[1] REDLINE REVISION NO. 1 — SEPTEMBER 2012
9/14/2012
TEDD APPROVAL — SHA NO. XX4395185

MD 355 (FREDERICK ROAD) AT GUNNERS BRANCH ROAD/
FOX CHAPEL SHOPPING CENTER
GERMANTOWN, MARYLAND

TRAFFIC SIGNALIZATION PLAN

TS NO. 3395B | DRAWING SG-1 OF 3 | SHEET NO. 1 OF 3

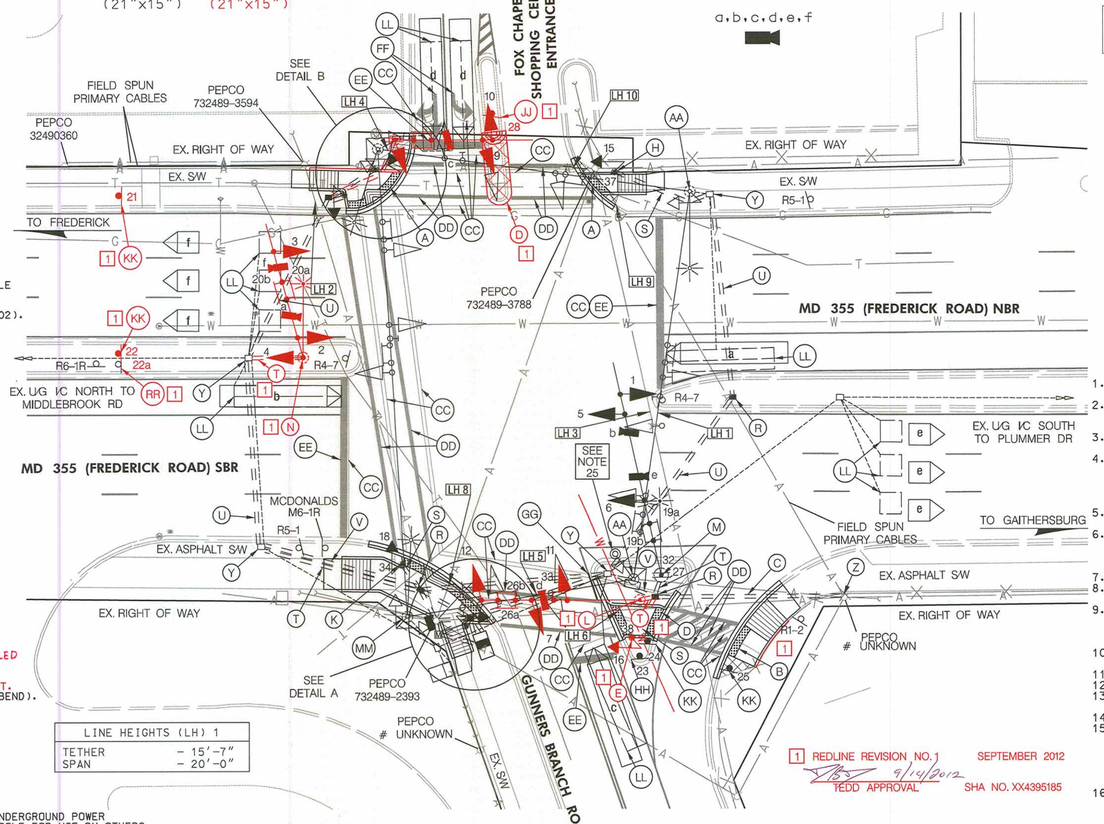
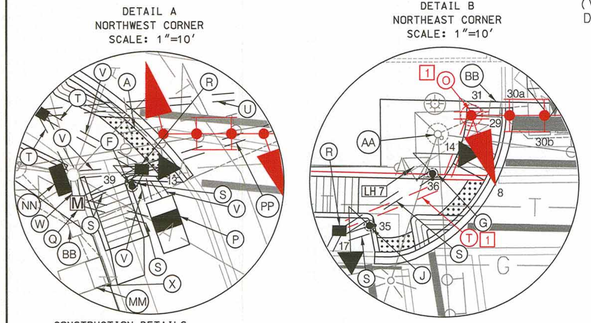
[1] 22 — TO SOUTH MARYLAND INTERNATIONAL 270 — M4-5 (24″x12″) M3-3 (24″x12″) M1-1 (30″x24″) M5-1 (21″x15″)

EXISTING SIGN ~~TO REMAIN~~ TO BE REMOVED — [1] 22a — TO SOUTH MARYLAND INTERNATIONAL 270

C. INSTALL 3 IN. SCHEDULE 80 RIGID PVC ELECTRICAL CONDUIT – SLOTTED (NOTE: 1-3 IN. 90 DEGREE PVC BEND).
[1] D. ~~REMOVE EXISTING CUT THROUGH AND INSTALL NEW CUT THROUGH AND DETECTABLE WARNING SURFACE PER MD STD. 655.40 (SEE NOTE 21 AND DETAIL ON SG-02). PULL BACK AND RECONSTRUCT MEDIAN NOSE (SEE NOTE 31). SEE SG-02 FOR DETAILS.~~

K. INSTALL A 10 FT. BREAKAWAY PEDESTAL POLE WITH FOUNDATION SHA STD. MD 801.01-01, BREAKAWAY COUPLINGS, LED COUNTDOWN PEDESTRIAN SIGNAL HEAD, ACCESSIBLE PUSHBUTTON (ARROW RIGHT) AND SIGN R10-3(1) "PUSH BUTTON TO CROSS FREDERICK ROAD" (NOTE: 1-2 IN. 90 DEGREE PVC BEND).
[1] L. INSTALL A 16.5 FT. STEEL POLE WITH A 15 FT. "I" DIMENSION, ~~38 FT. MAST ARM.~~ 50 FT. MAST ARM CUT TO 44 FT. FOUNDATION, LED TRAFFIC SIGNAL HEADS, SIGNS, AND VIDEO DETECTION CAMERA (NOTE: 1-3 IN. 90 DEGREE PVC BEND).
[1] M. INSTALL A 27 FT. STEEL POLE WITH A 60 FT. MAST ARM, FOUNDATION, LED TRAFFIC SIGNAL HEADS, VIDEO DETECTION CAMERAS, SIGNS AND 20 FT. LIGHTING ARM WITH A ~~250 WATT HPS~~ LED LAMP AND LUMINAIRE (NOTE: 1-3 IN. 90 DEGREE PVC BEND).
[1] N. INSTALL A ~~16.5~~ 27 FT. STEEL POLE WITH A ~~15 FT. "I" DIMENSION, 50~~ 38 FT. MAST ARM, FOUNDATION, LED TRAFFIC SIGNAL HEADS, VIDEO DETECTION CAMERAS, ~~AND~~ SIGNS AND A 20 FT. LIGHTING ARM WITH A ~~LED~~ LAMP AND LUMINAIRE (NOTE: 1-3 IN. 90 DEGREE PVC BEND).

JJ. INSTALL GROUND MOUNTED SIGN ON ONE (1) 4 IN. X 4 IN. WOOD POST SUPPORT.
KK. INSTALL GROUND MOUNTED SIGN ON ONE (1) 4 IN. X 6 IN. WOOD POST SUPPORT.
LL. ABANDON EXISTING LOOP DETECTOR.
MM. REMOVE EXISTING TRAFFIC SIGNAL EQUIPMENT. THE CONTRACTOR SHALL CONTACT PEPCO TO PERFORM A "WORK WITH" TO DISCONNECT THE EXISTING POWER FEED. REMOVE FOUNDATION 12 IN. BELOW GRADE AND BACKFILL. CAP AND ABANDON EXISTING CONDUIT.
NN. INSTALL MONTGOMERY COUNTY SPLICE CABINET ON EXISTING UTILITY POLE (NOTE: 1-3 IN. AND 1-4 IN. 90 DEGREE PVC BENDS).
PP. INSTALL 3 IN. SCHEDULE 80 RIGID PVC ELECTRICAL CONDUIT – SLOTTED (SEE NOTE 24).
[1] RR. REMOVE EXISTING GROUND MOUNTED SIGN AND SUPPORT.

29. SEE GENERAL INFORMATION SHEET (3 OF 3) FOR CABINET, SIGNAL POLE AND MAST ARM DETAIL LAYOUTS.
30. ALL ACCESSIBLE PEDESTRIAN CONTROL EQUIPMENT SHALL BE DELIVERED TO MONTGOMERY COUNTY FOR TESTING PRIOR TO INSTALLATION. CONTACT MR. ROBERT RICKETTS TO COORDINATE AT 301-279-1291.
[1] 31. THE CONTRACTOR SHALL FILL THE AREA OF THE REMOVED MEDIAN NOSE WITH CONCRETE.
